Model 122L, 32L, 32R, 225L, 232L, 225R, 232R

Trimmer head Trimmy H II

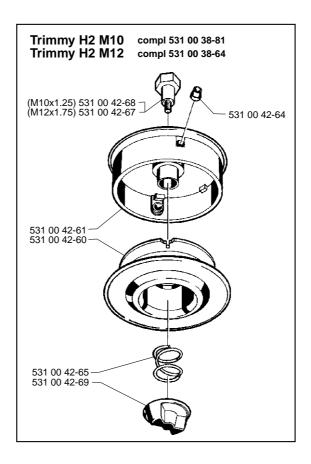
The knob is now made of zinc instead of plastic. The thread size has also been increased from M8 V to M10 V.

New Ref. no.	Description	Excl. Ref. no.	Remark
531 00 42-67	Adapter M12x1.75 (M10 V)	531 00 42-62	R
531 00 42-68	Adapter M10x1.25 (M10 V)	531 00 42-63	R
531 00 42-69	Knob, zinc (M10 V)	531 00 42-66	R
